LSD Dwight Rich Food Service Bid Pack 2, Addendum No. 1

Narrative of Changes

Project Name:	Dwight Rich Food Service – Equipment Replacement & Renovation SO-1854	Date:	April 03, 2026
Project Location:	2600 Hampden, Lansing, MI 48911	Architect’s Project #:	25015929A
Owner/Client:	Lansing School District	Attention:	David Beckering
Issued to:	Beckering Construction	Email:	djb@beckering.com
City/State:	Grand Rapids, MI	Zip:	49548

A101

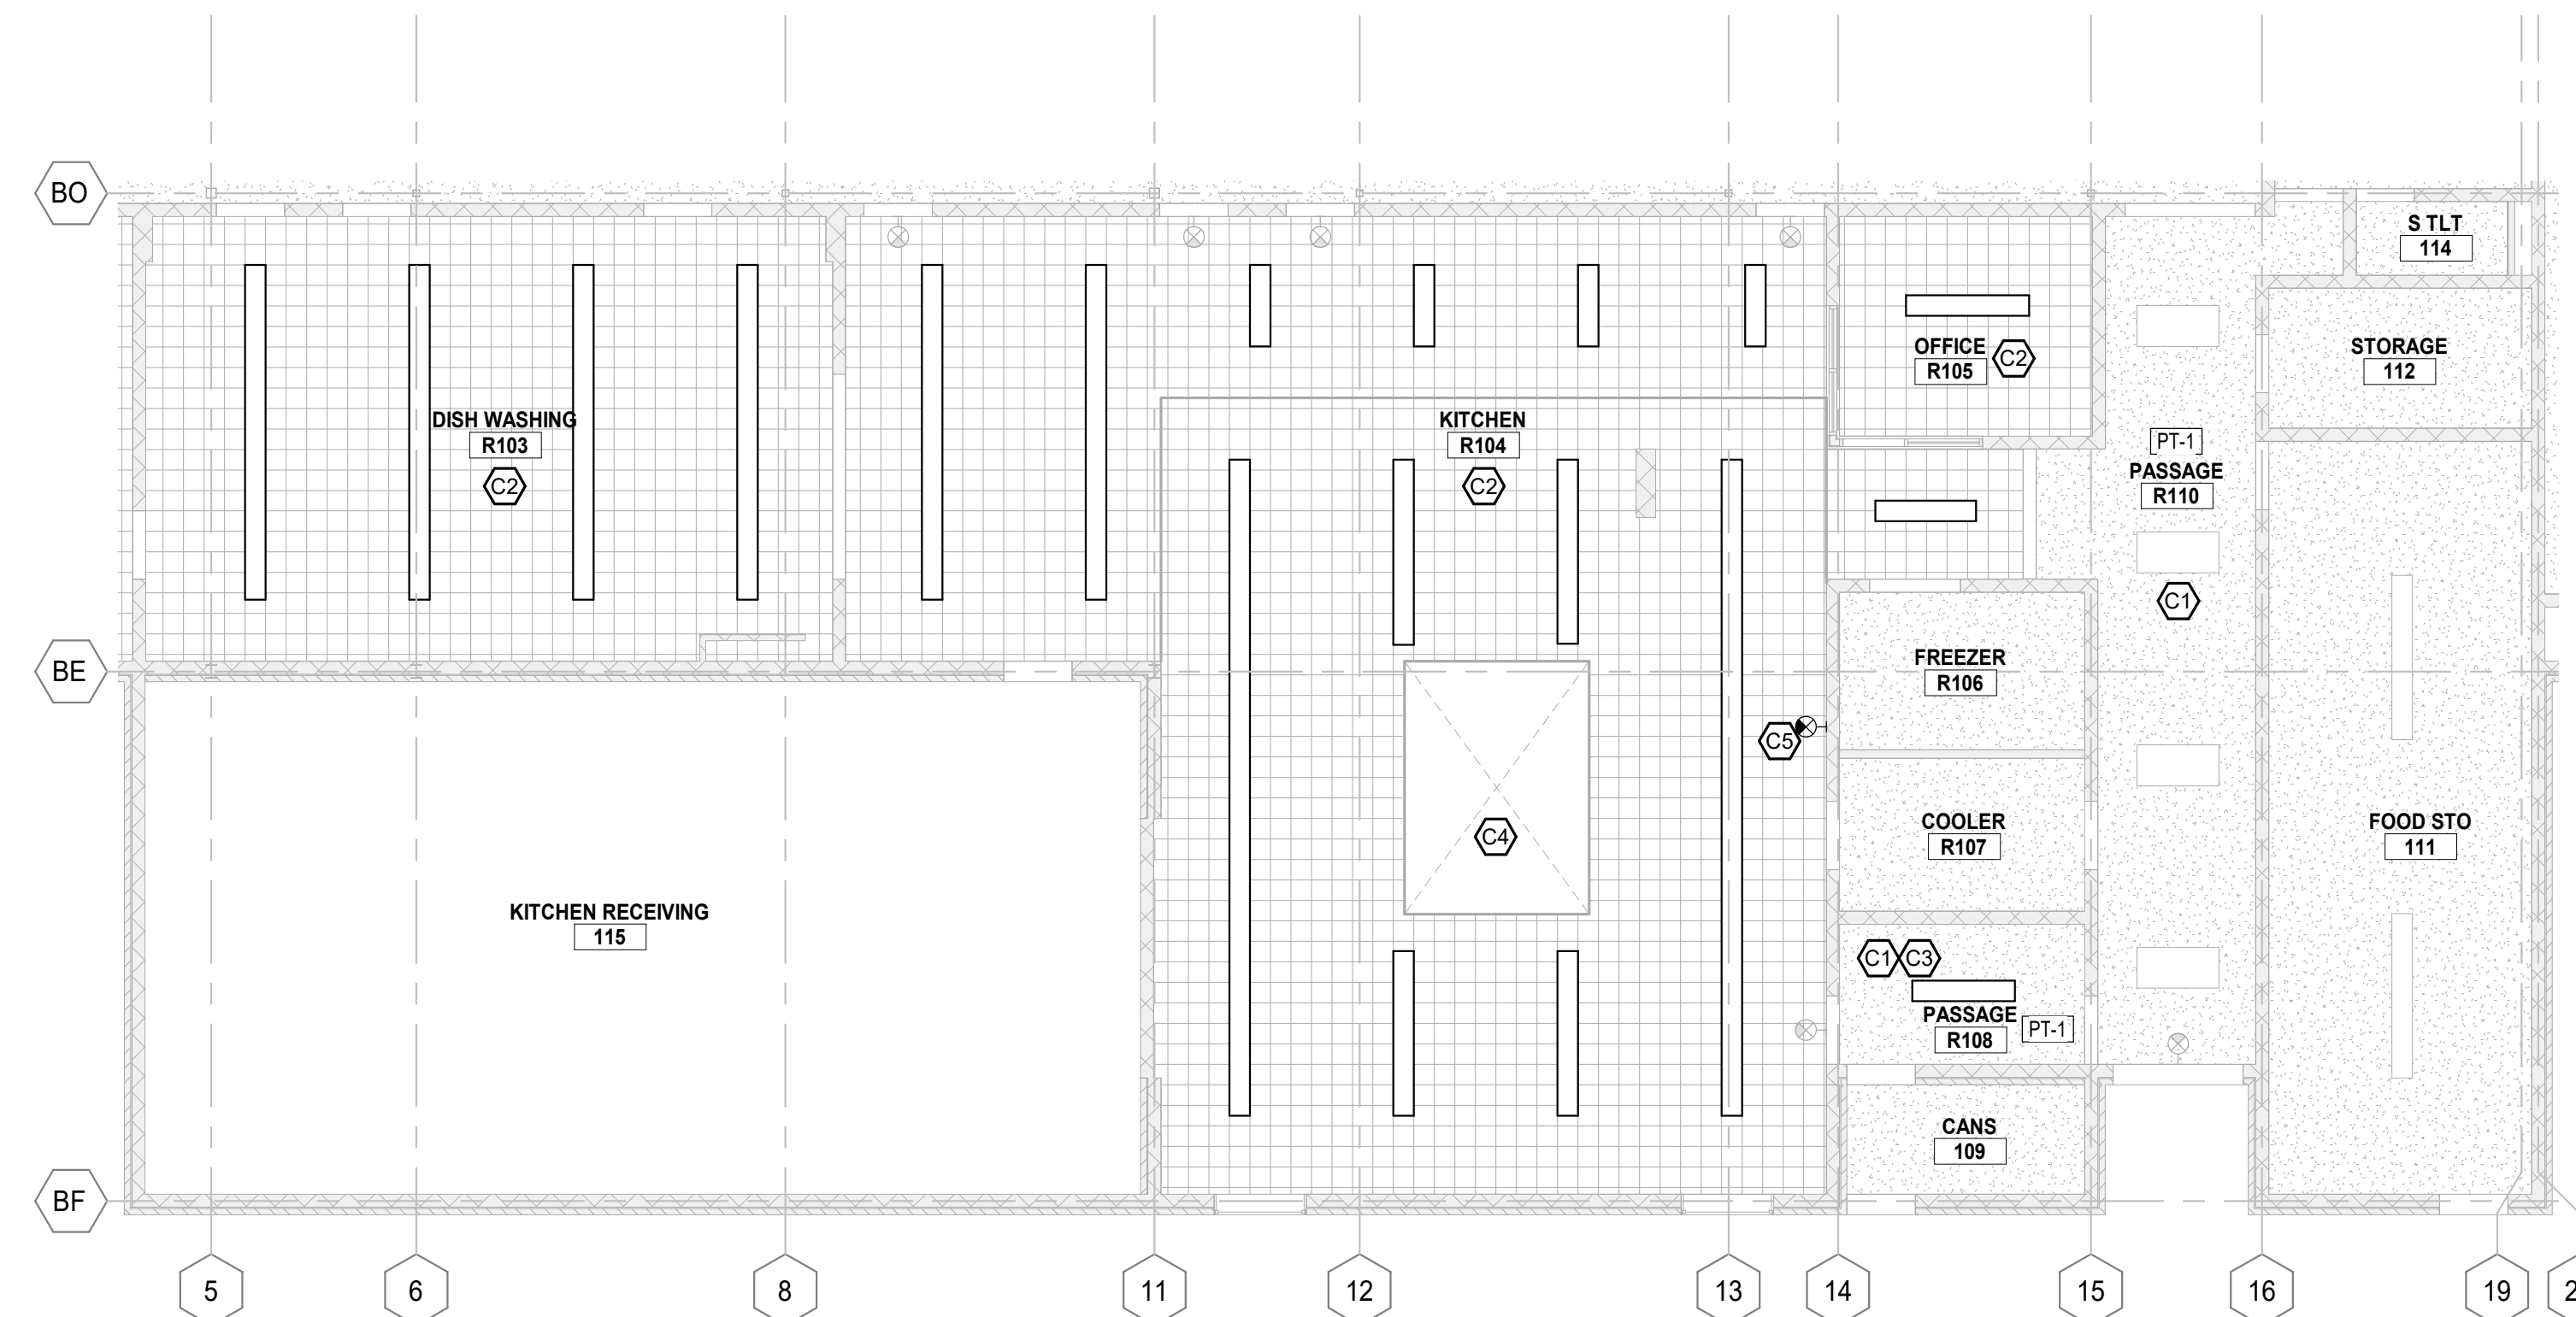
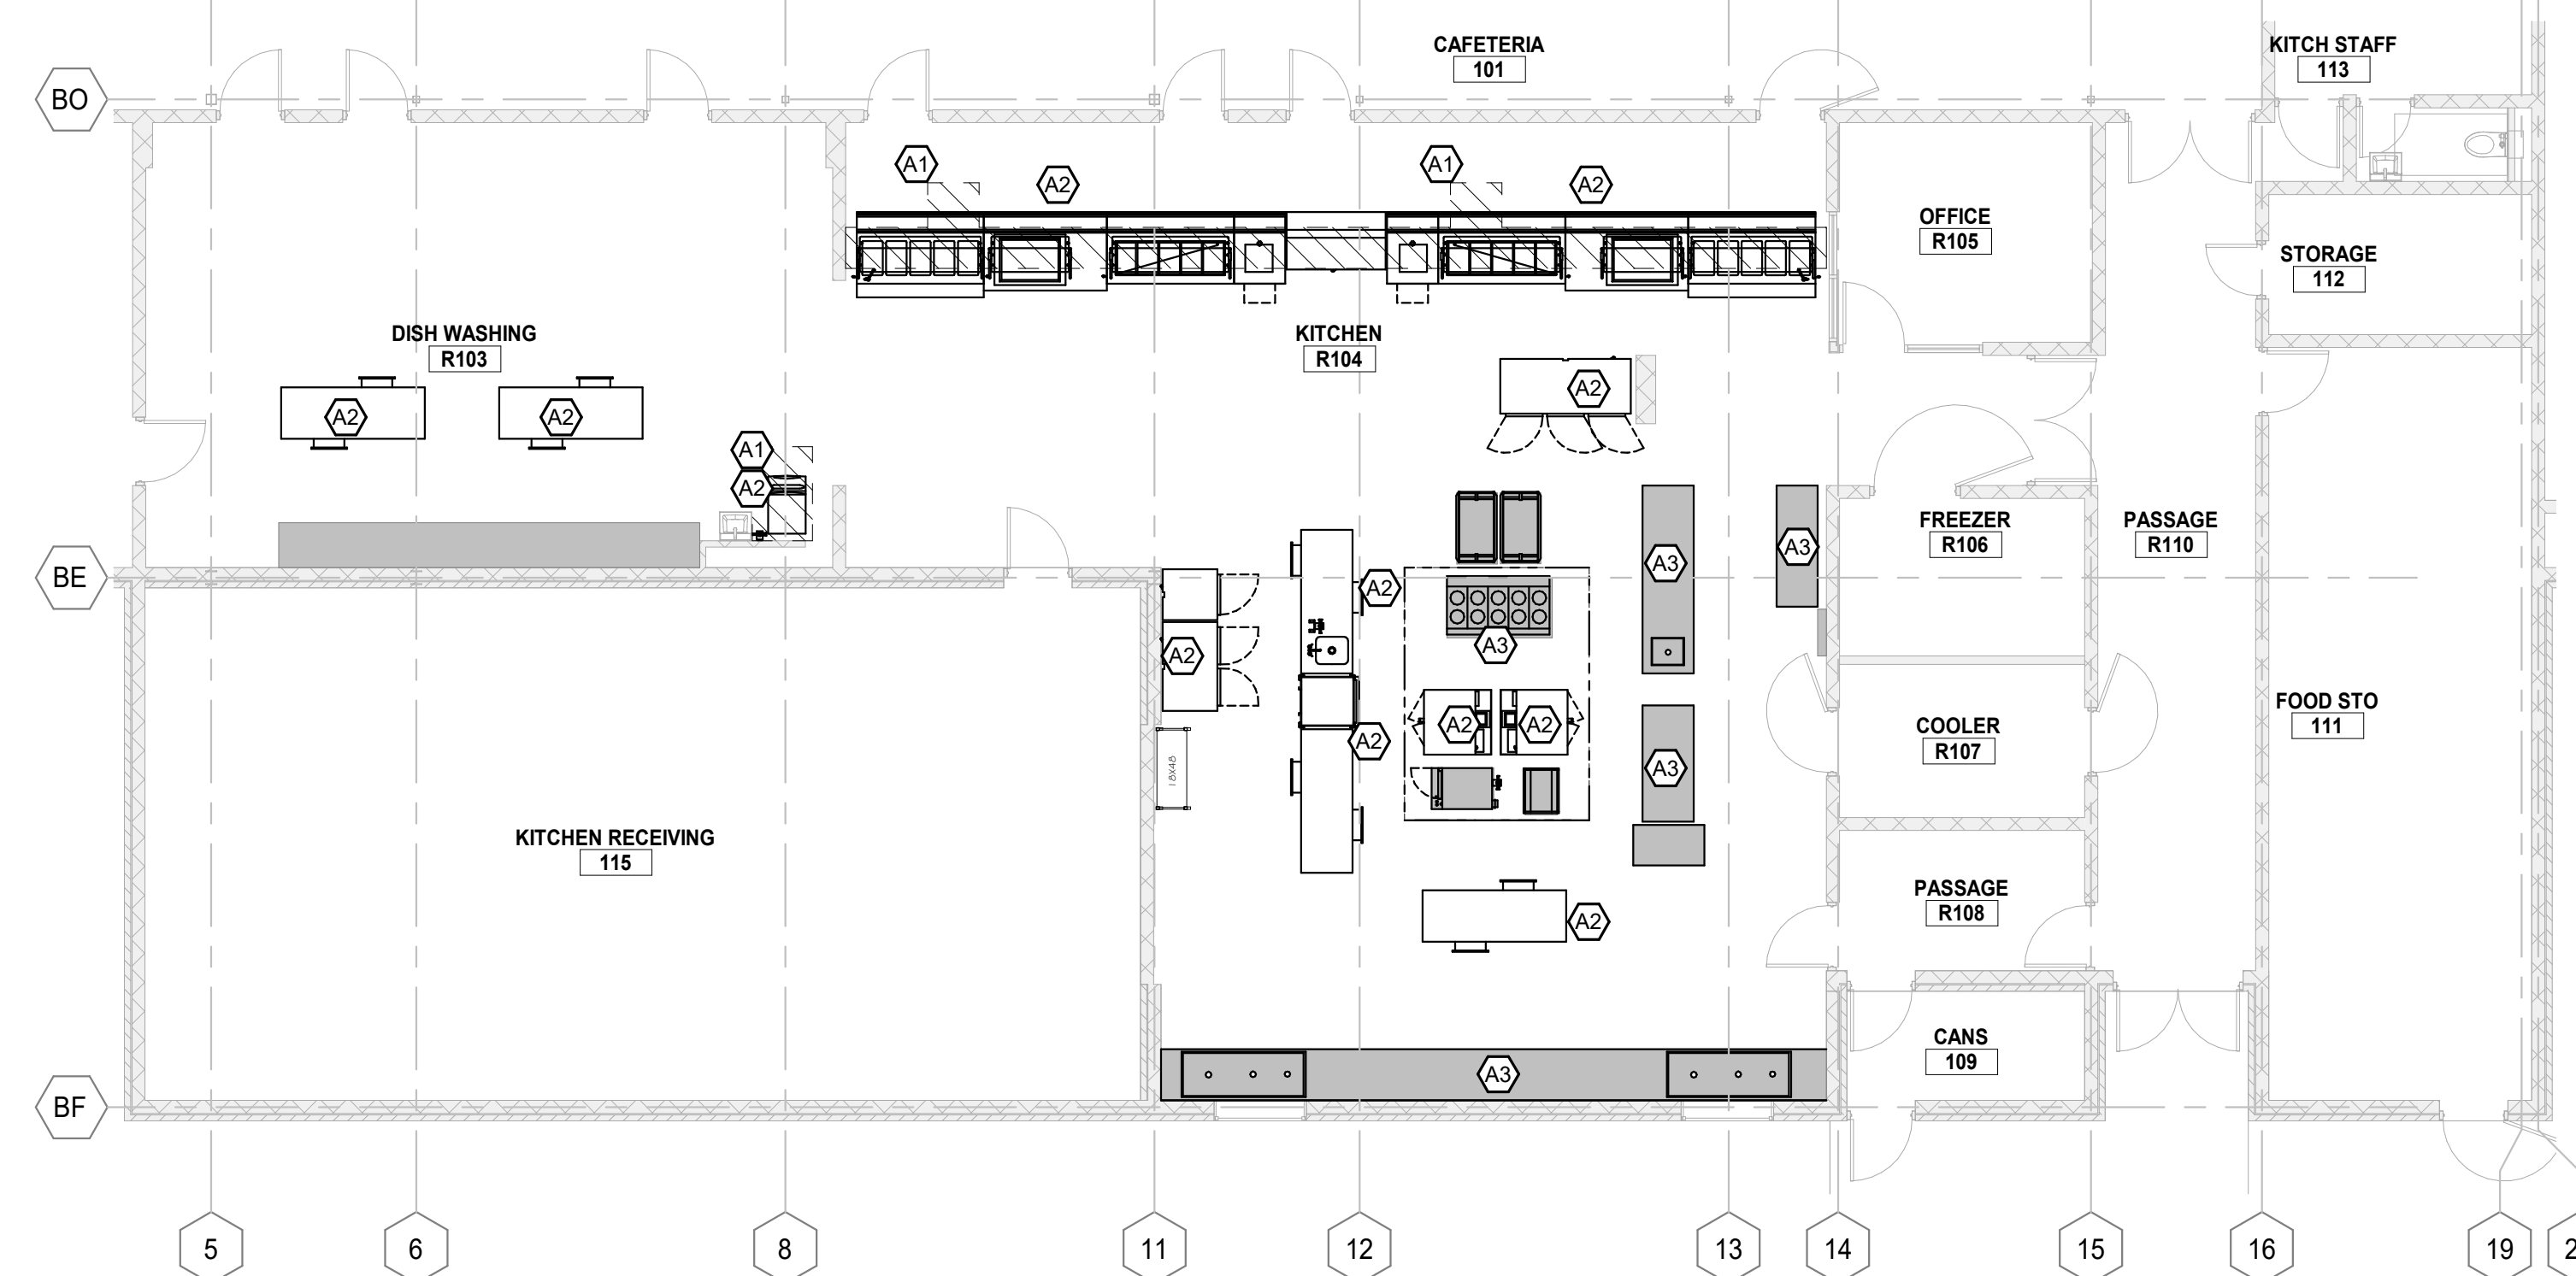
- A101 – FIRST FLOOR AND CEILING PLANS (Reissued)
 - Revised paint specifications

099123 - INTERIOR PAINTING:

- A. BASIS OF DESIGN MANUFACTURER: SHERWIN WILLIAMS. ALSO ACCEPTABLE: BENJAMIN MOORE AND PPG PAINTS.
- B. PREPARATION OF SURFACES TO RECEIVE PAINT: CLEAN, DRY, DULL, AND SOUND.

- C. PAINT SYSTEMS:
 - a. GYPSUM BOARD AND PLASTER:
 - PRIMER: PROMAR 200 ZERO VOC INTERIOR LATEX PRIMER, B28W2600
 - 1. 4.0 MILS WET, 1.0 MILS DRY.
 - INTERMEDIATE COAT: MATCH TOPCOAT.

- TOPCOAT: PROMAR 200 ZERO VOC INTERIOR LATEX EG-SHEL, B20-2600 SERIES.
 - 1. 4.0 MILS WET, 1.6 MILS DRY.
 - b. GYPSUM BOARD AND PLASTER CEILING:
 - PRIMER: LOXON CONCRETE & MASONRY PRIMER AS NEEDED ON NEW PLASTER

- INTERMEDIATE COAT: MATCH TOPCOAT
 - TOPCOAT: PRO INDUSTRIAL WATERBORNE ACRYLIC DRY FALL, FLAT, B42-80 SERIES
 - c. CMU:
 - PRIMER: EXTREME BOND PRIMER, B51 SERIES

- 1. 3.1 MILS WET, .9 MILS DRY.
 - ADHESION TEST: USE PRINCIPLES OF ASTM D3359 AFTER MINIMUM 7 DAY CURE TIME OF PRIMER TO ENSURE 90% OF COATING CONTINUES TO ADHERE. CONTACT COATINGS MANUFACTURER FOR ASSISTANCE AS NEEDED.

- INTERMEDIATE COAT: MATCH TOPCOAT.
 - TOPCOAT: PRO INDUSTRIAL PRE-CAT EPOXY ED-SHEL, K45-2150 SERIES.
 - 1. 4.0 MILS WET, 1.6 MILS DRY PER COAT.
 - d. HOLLOW METAL FRAMES AND DOORS:

- PRIMER: PRO INDUSTRIAL PRO CRYL UNIVERSAL PRIMER, B66-310 SERIES.
 - 1. 5.0 TO 10 MILS WET, 2.0 TO 4.0 MILS DRY.
 - INTERMEDIATE COAT: MATCH TOPCOAT.
 - TOPCOAT: PRO INDUSTRIAL ACRYLIC SEMI-GLOSS COAT, B66-650 SERIES.

- 1. 2.5 TO 4.0 MILS DRY PER COAT.
- D. COLORS: REFER TO BASIS OF DESIGN.
